WATTS BAR NUCLEAR PLANT (WBN) UNIT 1 - RESPONSE TO REQUEST FOR  
ADDITIONAL INFORMATION REGARDING REQUEST FOR LICENSE AMENDMENT TO  
TECHNICAL SPECIFICATIONS - SPENT FUEL POOL STORAGE CAPACITY  
INCREASE (TAC NO. M96930)

WATTS BAR NUCLEAR PLANT (WBN) UNIT 1  
REQUEST FOR ADDITIONAL INFORMATION  
SPENT FUEL POOL STORAGE CAPACITY

**FIGURE 1**

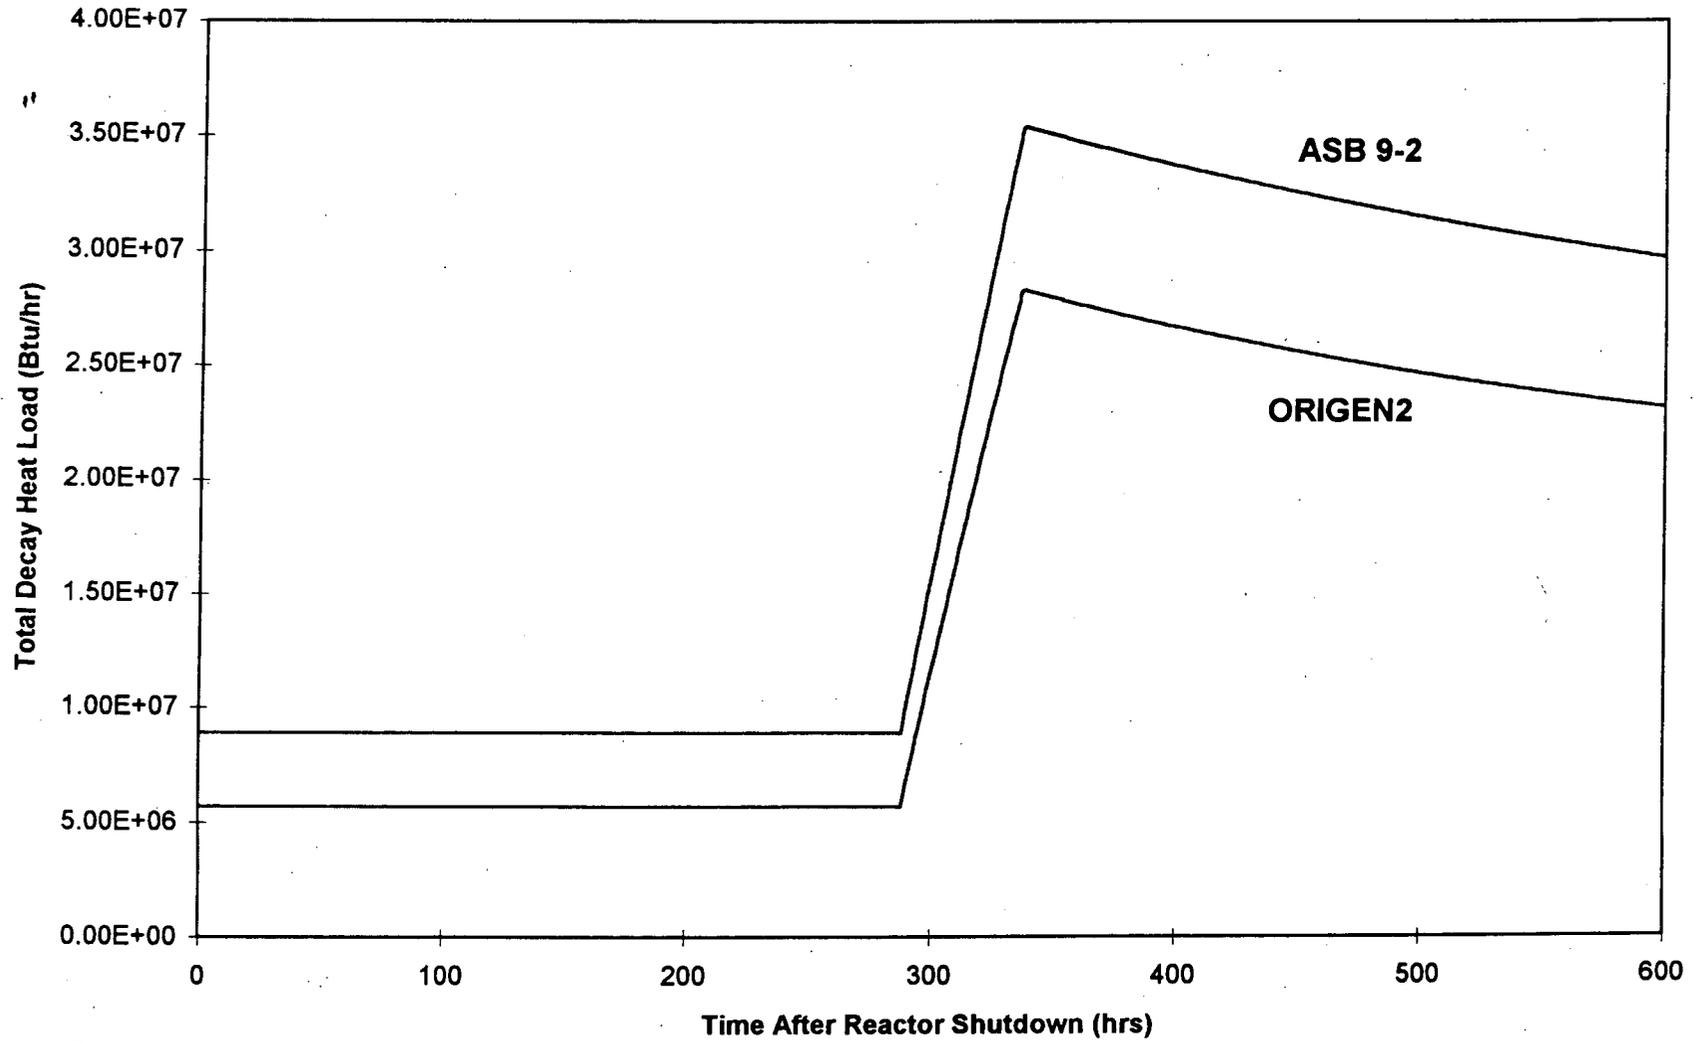
With regard to the calculated decay heat loads following the proposed pool expansion, provide the following information:

- a. the decay heat generation rate as a function of decay time for both the maximum normal and maximum abnormal conditions (information should clearly show the decay heat generation rate from each batch of the previously discharged spent fuel assemblies and the freshly discharged full core in the spent fuel pool); and
- b. a comparison of the assumptions used in the decay heat calculations to the guidance described in Section 9.1.3 of the Standard Review Plan (SRP, NUREG-0800) including the Branch Technical Position ASB 9-2, "Residual Decay Energy for Light Water Reactors for Long-Term Cooling."

- a. The decay heat generated by the previously stored assemblies in accordance with the discharge schedule assumed in Section 5.3 of the report attached to the license amendment request is provided in the attached Table 1 for ORIGEN2 and ASB 9-2.

The total decay heat load corresponding to the normal full core discharge (Case 1) and unplanned full core discharge (Case 2) can be found in Figures 5.5.6 and 5.5.8, respectively, of the report. Attached Figure 1 shows the total decay heat load plot using ORIGEN2 (duplicated from Figure 5.5.6) and ASB 9-2 procedures. It is noted that the ASB 9-2 procedures yield decay heat values which are approximately 27% greater than the more accurate ORIGEN2 results.
